Item ID: D206-642-341 Accept ***N900040100*** Setup Start ***NS1***
Revision ID: Stop ***NS2***
Item Name: Replacement Skidtube (Fits LH or RH)
Start Date: 8/17/2016 Start Qty: 1.00 ***1*** Cust Item ID:
Required Date: 8/29/2016 Req'd Qty: 1.00 ***1*** Customer:
Reference:

DESIGN	DS	DART AEROSPACE USA, INC	
DRAWN	AJS	PORT HADLOCK, WA	
CHECKED		DRAWING NO.	REV. F
MFG. APPR.		D2650	SHEET 2 OF 6
APPROVED		TITLE	SCALE
DE APPR.		206/407 SKIDTUBE ASSEMBLIES	NTS
DATE	08.08.08	COPYRIGHT © 1997 BY DART AEROSPACE USA, INC	
THIS DOCUMENT IS PRIVATE AND CONFIDENTIAL AND IS SUPPLIED ON THE EXPRESS CONDITION THAT IT IS NOT TO BE USED FOR ANY PURPOSE OR COPIED OR COMMUNICATED TO ANY OTHER PERSON WITHOUT WRITTEN PERMISSION FROM DART AEROSPACE USA, INC.

DRAWING NO. D2650	TITLE 206/407 SKIDTUBE ASSEMBLIES	REV. F	DART AEROSPACE LTD ENGINEERING ORDER		D.E.O. NO. D2650-F-1	SHEET NO. SHEET 1 OF 1	SCALE NTS
DRAWN <i>P</i>	CHECKED <i>A.P.</i>	MFG. APPR. <i>AA</i>	APPROVED <i>#</i>		DE APPR. <i>#</i>		
DATE 12.10.12	DATE 12.10.22	DATE 12.10.22	DATE 12.10.22		DATE 12.10.22

DETAIL G

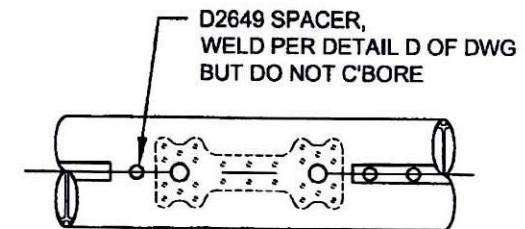
CHANGE C'BORED WELDED CROSSBOLT SPACERS TO SWAGED SPACERS

ADD DETAIL G BELOW, WHICH IS THE SAME SECTION VIEW AS DETAIL D OF DWG.

C'BORED HOLES ARE **NOW SWAGED** PER DETAIL G BELOW. FOR THE Ø0.375 HOLE THAT IS NOT C'BORED, WELD PER DETAIL D OF DWG (SEE AMENDED DETAIL B FOR REFERENCE).
